# Access Compliance Report

## Public Rights-of-Way

Intersection ID: 14267	Main Street: CLANTON_RD	Cross Street: FARMER_ST	Location: NW
ADA ID: 9AEC850B67AB	Ramp Type: Perp	Initial Pass/Fail: Fail	Overall Compliance: No
			Severity Score: 26.25

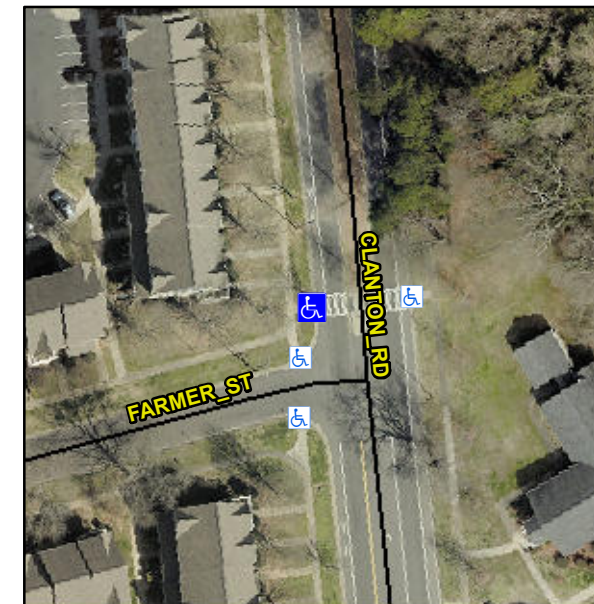
**R304.2.2, R304.5.3**

Compliance	Description	Data	Compliance	Description	Data
N/A	Ramp Length (in)	62.0	No	Ramp Slope (%)	13.2
Yes	Ramp Width (in)	48.0	No	Ramp XSlope (%)	4.9
N/A	Flare Type LT	N/A	N/A	Flare Type RT	N/A
N/A	Flare Slope LT (%)	N/A	N/A	Flare Slope RT (%)	N/A
N/A	Flare Traversable LT?	N/A	N/A	Flare Traversable RT?	N/A
N/A	Landing Length (in)	N/A	N/A	DWS Provided?	N/A
N/A	Landing Width (in)	N/A	N/A	DWS Contrast?	N/A
N/A	Landing Slope (%)	N/A	N/A	DWS Length (in)	N/A
N/A	Landing X Slope (%)	N/A	N/A	DWS Full Width?	N/A
N/A	Landing Curb? (Y/N)	N/A	N/A	DWS Offset (in)	N/A
N/A	Shared Landing?	N/A			
N/A	Gutter Ponding?	N/A	N/A	Gutter Slope (%)	N/A
N/A	Gutter Lip Ht (in)	N/A	N/A	Gutter X Slope (%)	N/A
N/A	Painted X Walk1?	Yes	N/A	Painted X Walk2?	N/A
	X Walk 1 Direction	To E		X Walk 2 Direction	N/A
N/A	X Walk 1 Width (in)	117.0	N/A	X Walk 2 Width (in)	N/A
	X Walk 1 Slope (%)	5.8		X Walk 2 Slope (%)	N/A
	X Walk 1 X Slope (%)	4.7		X Walk 2 X Slope (%)	N/A

**Remove & Replace Entire Ramp.**
